3.4 COMMENTS FROM INDIVIDUALS AND RESPONSES (COMMENT LETTERS 14–62)

Written comments on the Cowell Ranch / John Marsh State Historic Park GP and EIR received from individuals are presented on the following pages. Each comment letter is followed by the responses to that letter.

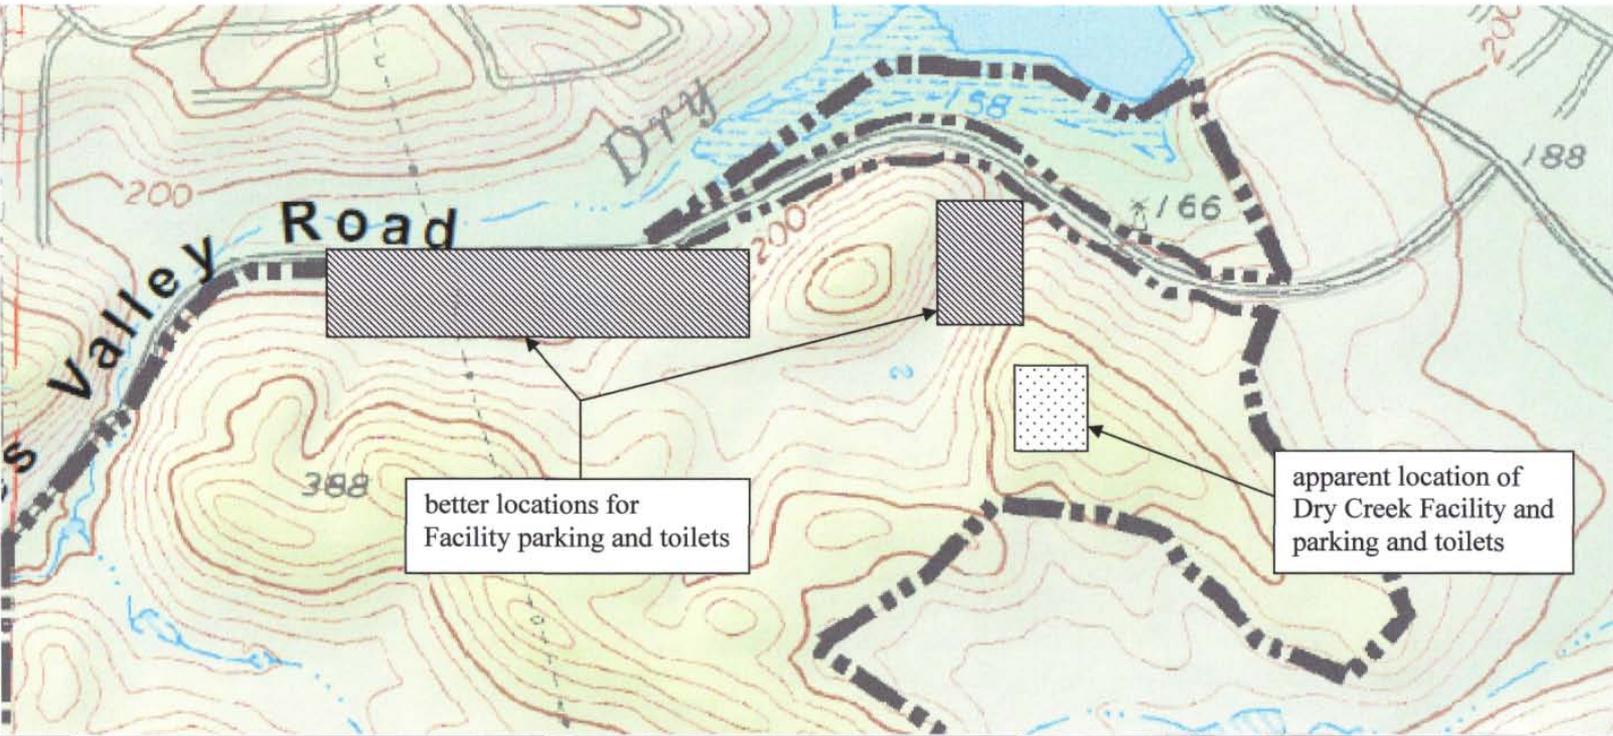
A better plan would locate the parking lot and toilets at a lower elevation and provide a short path to an overlook and birdwatching area on top of the hill (or on one of the adjacent hills). Attached is part of Map 4 marked up to show the apparent proposed location for the Dry Creek Facility and its parking lot and toilets, and also show suggested alternate locations for the parking lot and toilets that would be off the hilltops and less conspicuous but still convenient to potential hilltop overlooks.

better locations for Facility parking and toilets

apparent location of Dry Creek Facility and parking and toilets

- 29-2:** Please refer to Master Response 1, Program-level Analysis and Facility Siting. The specific location of proposed facilities in the Dry Creek Visitor Facility Zone has not yet been identified. Siting of proposed facilities will occur during project-level planning for projects proposed under the GP. Future projects will undergo subsequent environmental review as appropriate.
